- A. Model V300/V3.4 Litre Flywheel Torque
- B. Serial Numbers
- C. Spark Plug Fouling - Model V150 and V200

#### A. MODEL V300/3.4 LITRE FLYWHEEL TORQUE

#### C. SPARK PLUG FOULING - MODEL V150 and V200

Figure 1.

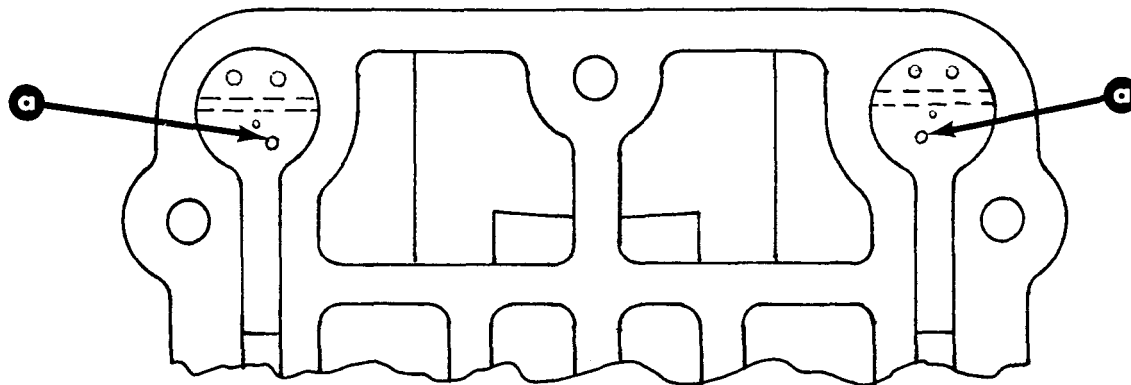
1. Using a hand held pin vise, enlarge the second progression to .052 (Figure 1).
2. Install .056 idle jets. (Rejet the idle circuit as noted in Step 2 preceding.)

1. Using a hand held pin vise, enlarge the second progression hole to **.046** (Figure 1).
2. Install .056 idle jets. (Rejet the idle circuit as noted in Step 2 preceding.)
